RE: Lena Road Landfill – Operational Changes
Pending Modification No.: 39884-007
Permit No.: #39884-001-SO, Manatee County

PBS&J is providing four copies of this response to your November 9, 2001 letter requesting additional information in regards to the above referenced permit modification. The following numbered items are from your letter. Our response follows each item.

**RE: Lena Road Landfill
Second Partial Closure
HDR Project Number: 07982-029-096**

Gas collection
System for
Leachate Pond

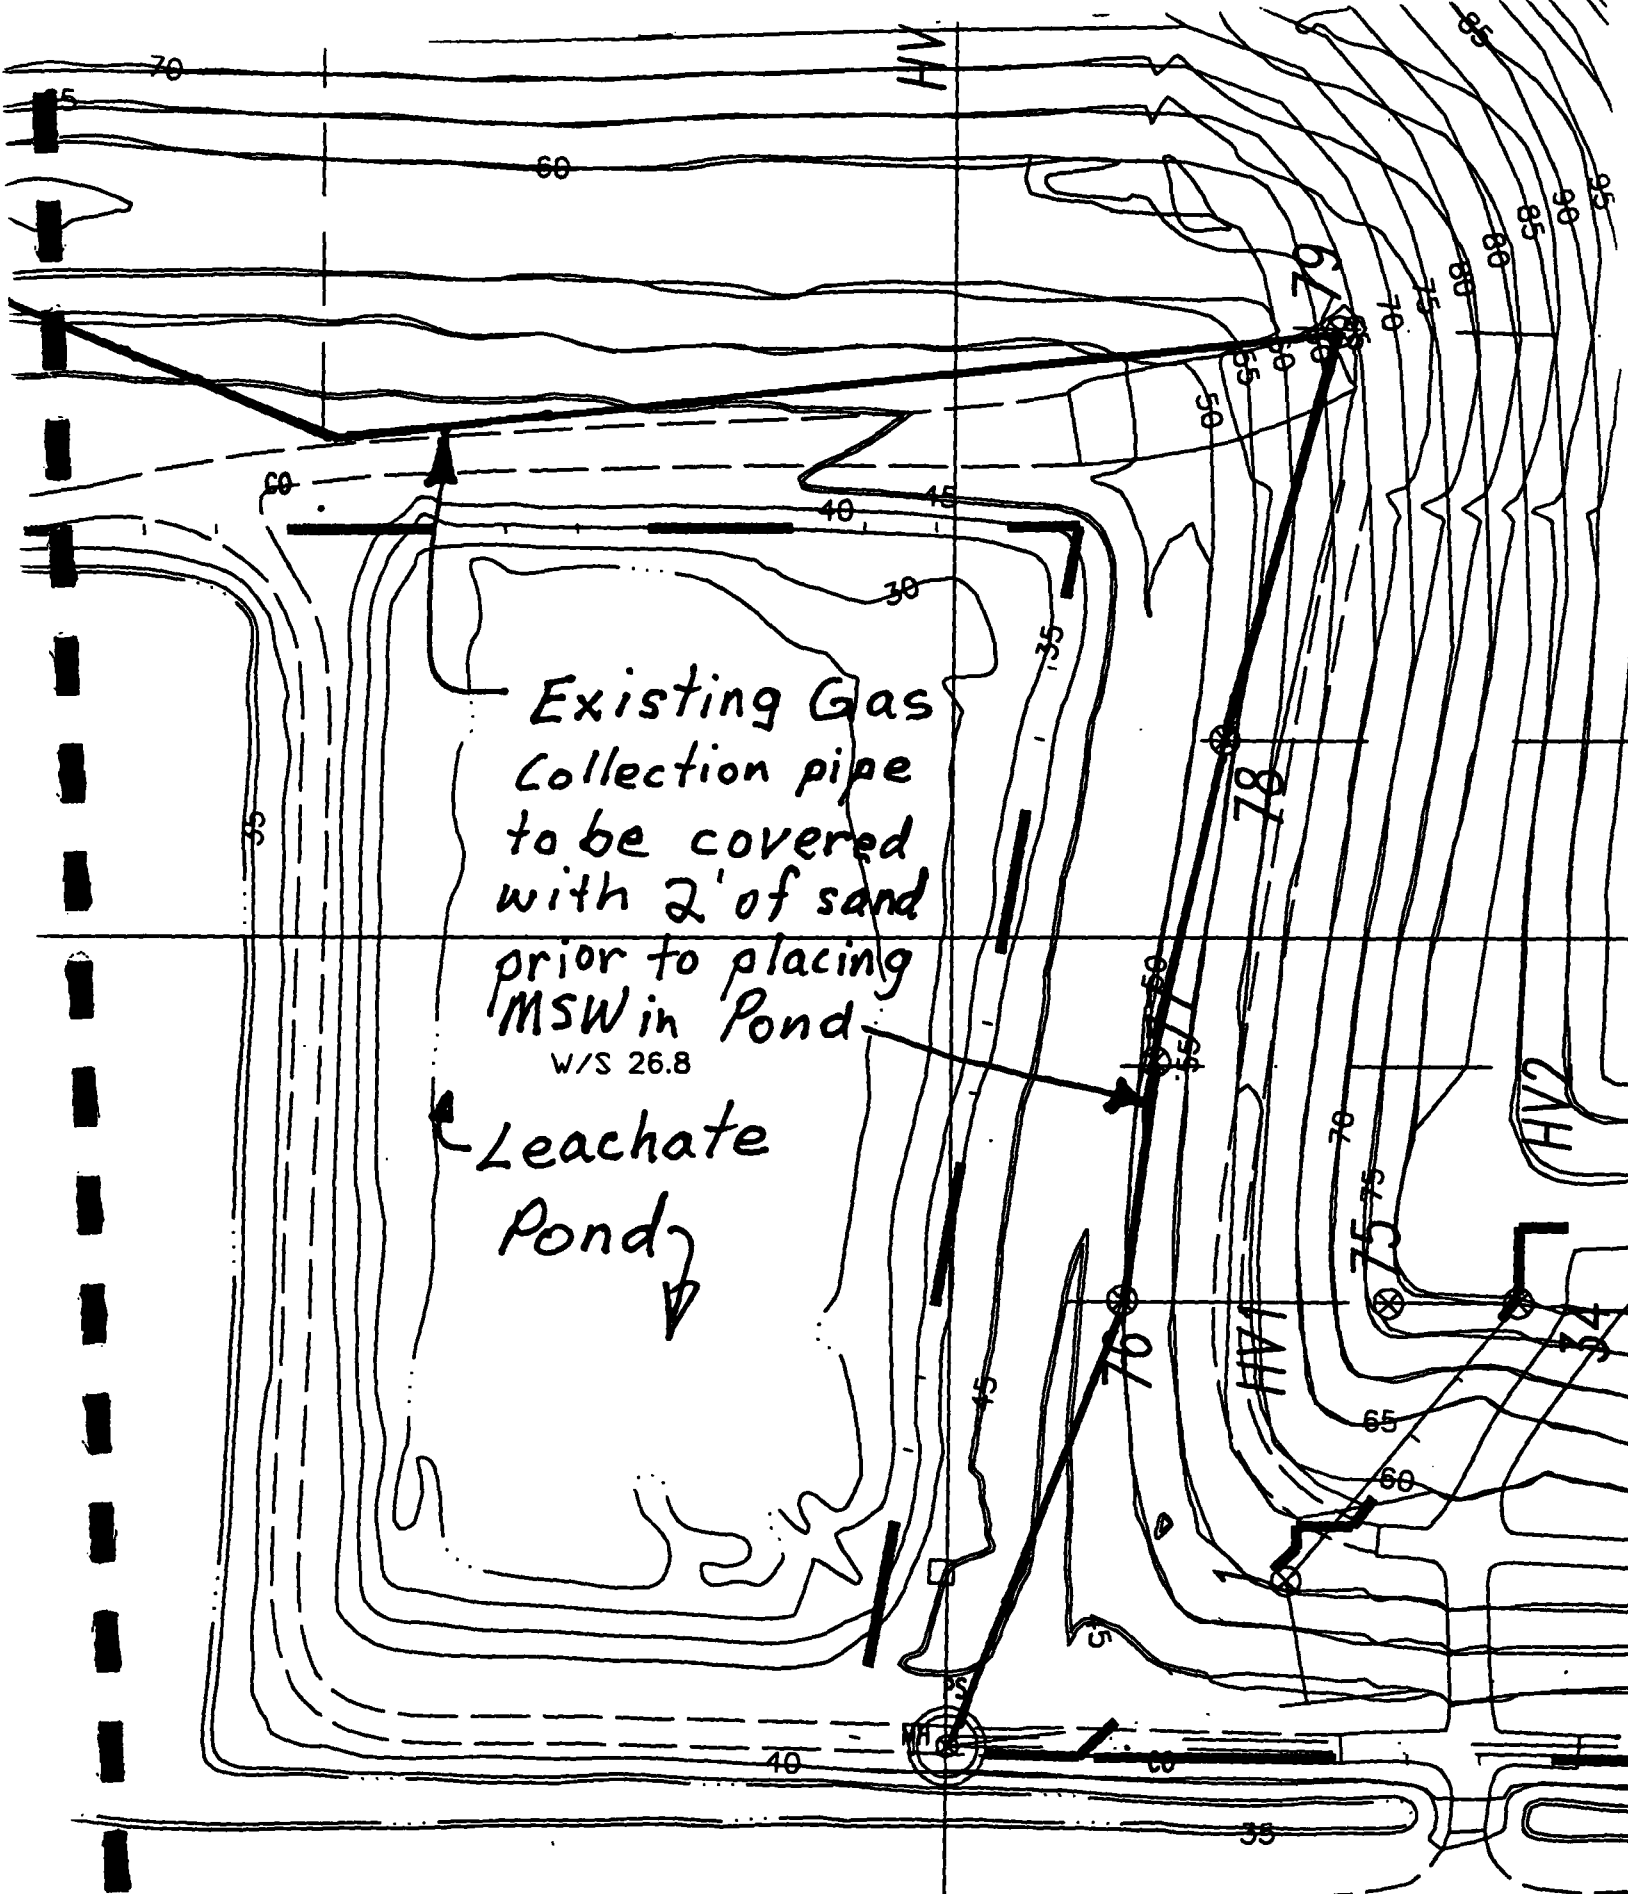
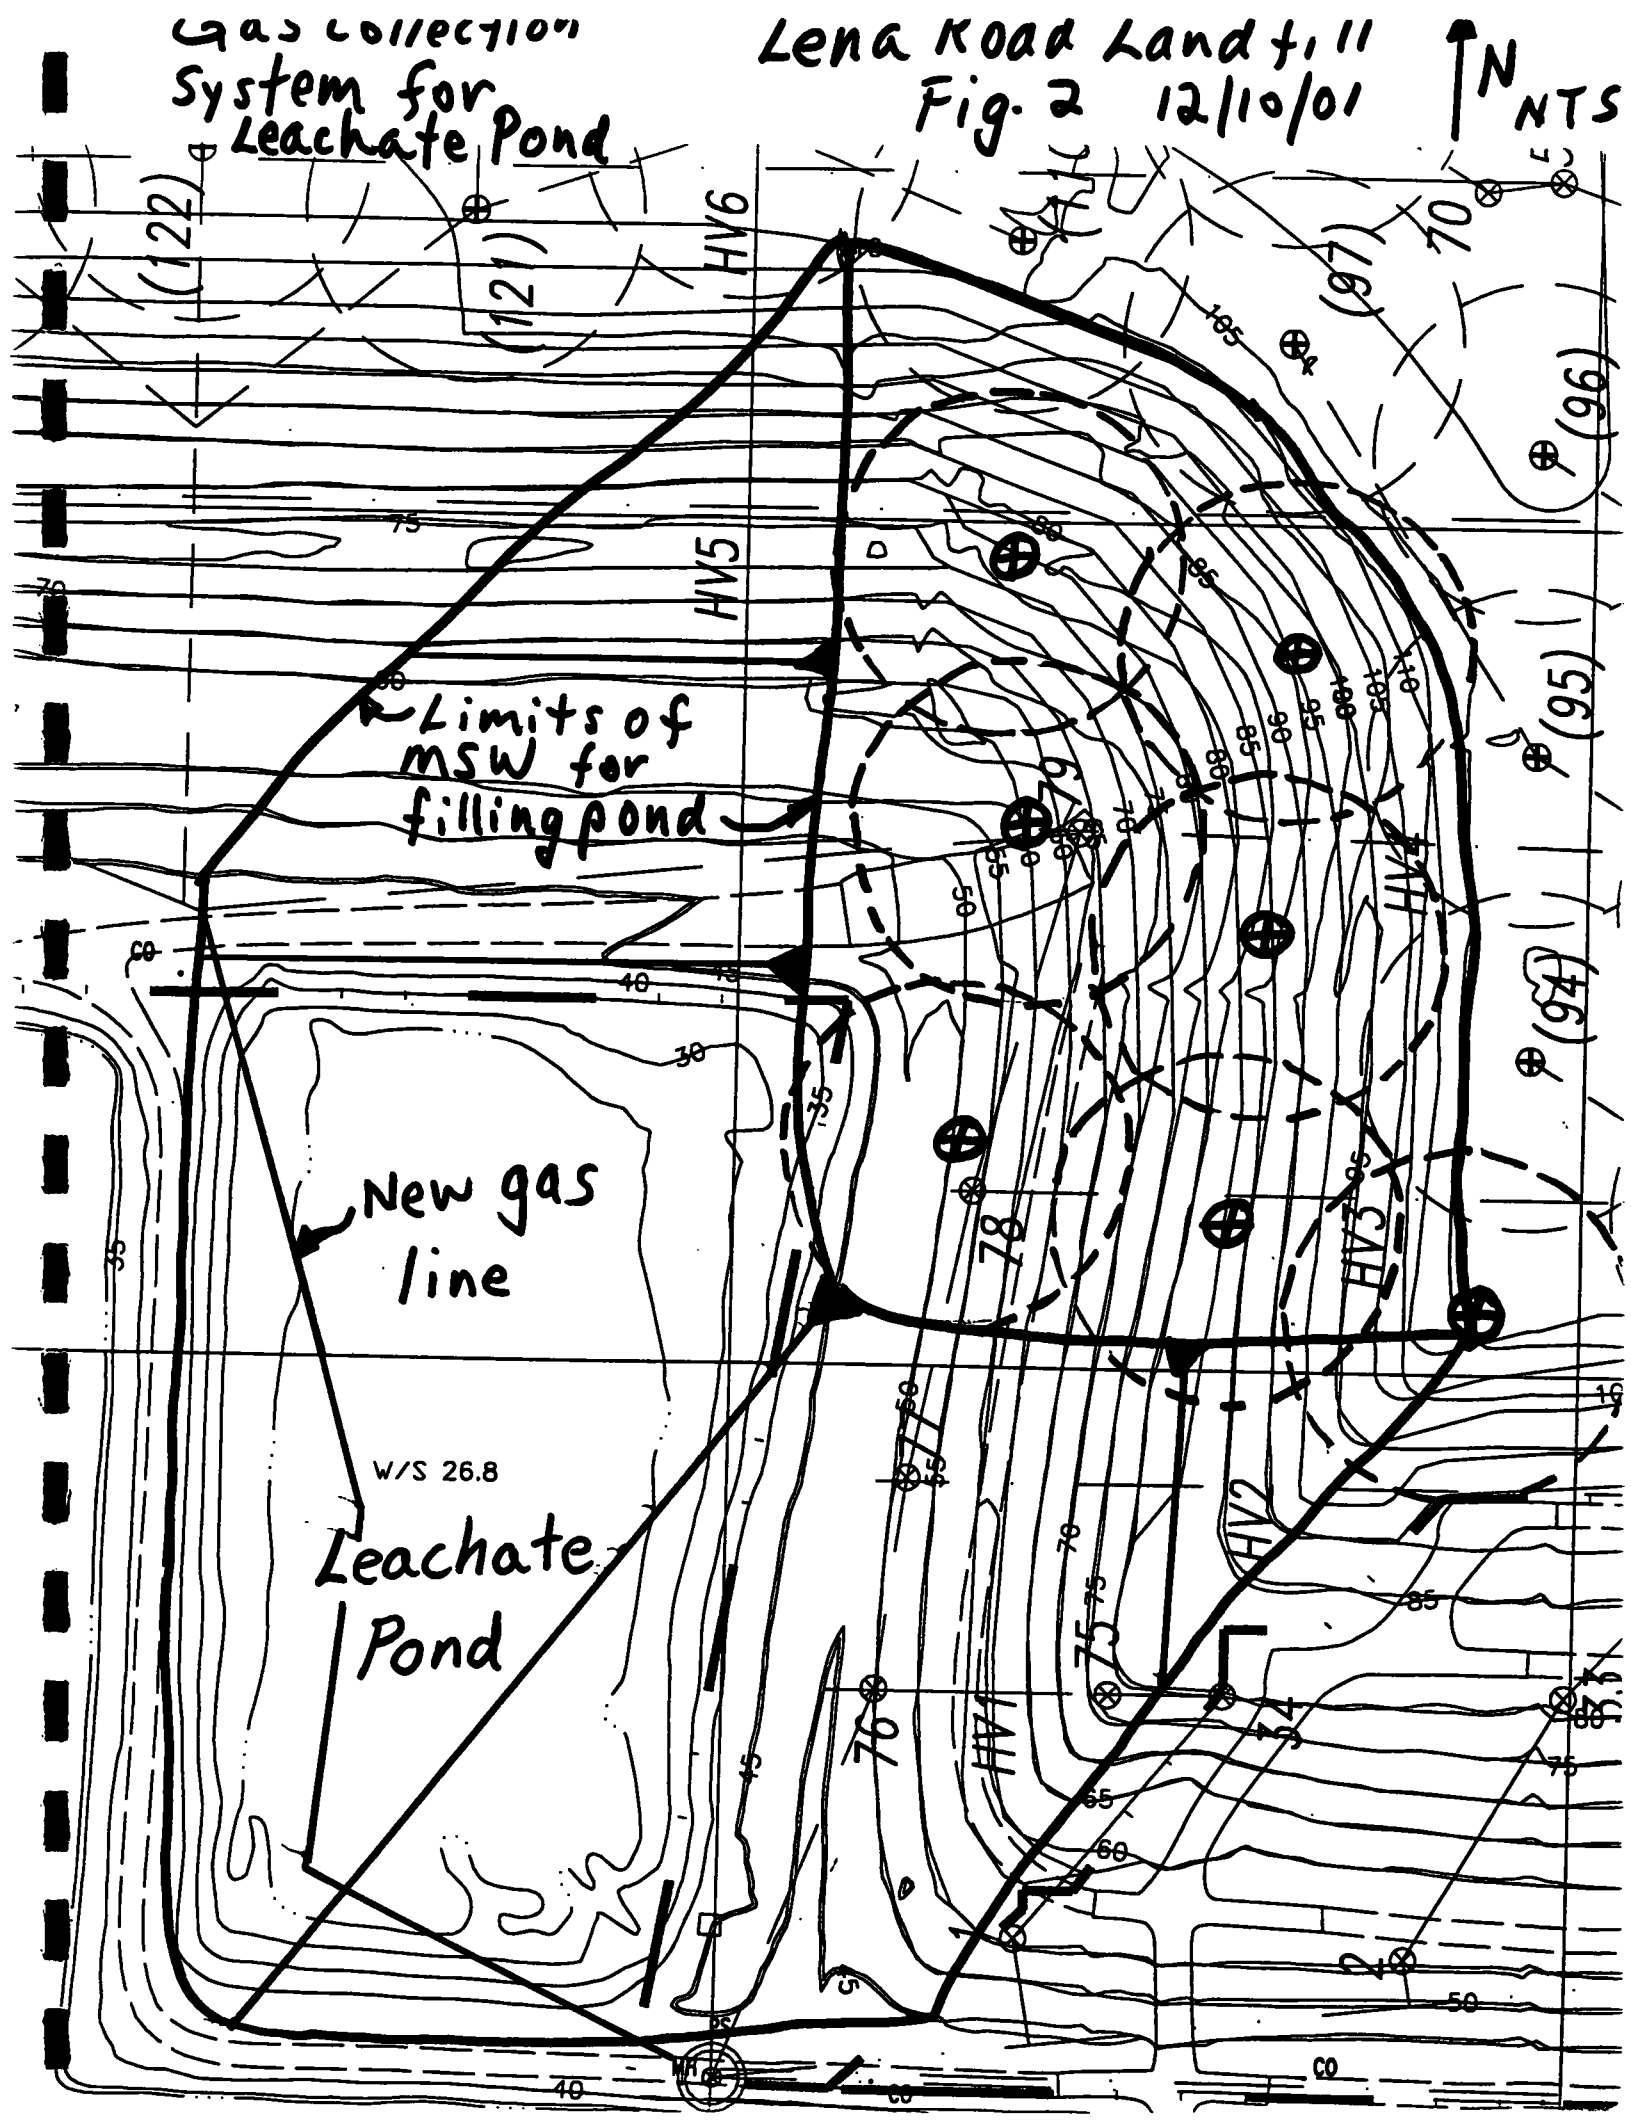
6. 62-701.530. Design details for expansion of the gas management system due to the disposal area expansion.

Response: Vertical wells will be installed as shown on Figure 2 in Section 1. The design details are those shown on the construction drawing C-09 – Landfill Gas Details for Lena Road Landfill Partial Closure Number 2, prepared by HDR Engineering, Inc., dated July 24, 2000.

METERING STATION DETAILS

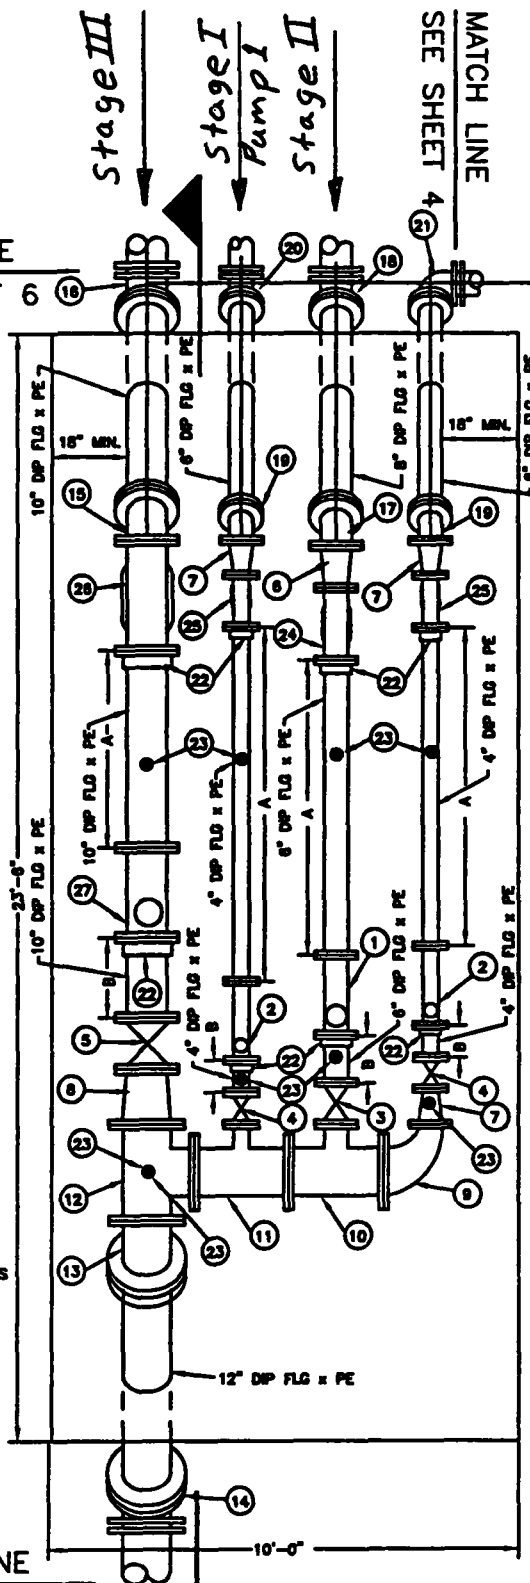
9. Revisions to the Stormwater/Leachate Management Plan are requested. Pages 5, 6, 7, and 8 (provided on October 11th) are from an older version and should not be included. (a) Page 4 (dated November 1998) and page 5 (dated February 17, 2000) should be revised to describe the phasing-out of the leachate storage pond. (b) Pages 6 and 7 (date November 1998) should be revised to delete references to the leachate pond.

The Metering Station is shown on Figure 3. Four pipelines come to the Metering Station from the landfill, and one pipeline leaves the Metering Station. There are two pump stations for the Stage I landfill, one for Stage II and one for Stage III. The flow in each pipeline is individually metered at the Metering Station. After metering, the pipelines are manifolded into a single 12-inch pipeline for pumping the leachate to the storage tank at the adjacent wastewater treatment plant. The meters for Stage I – Pump 1 and Stage I – Pump 2 and Stage III will be recorded daily using Exhibit A (Revised December 5, 2001). The Stage II Landfill has no solid waste, and so the pipeline from the Stage II pump station is not used.
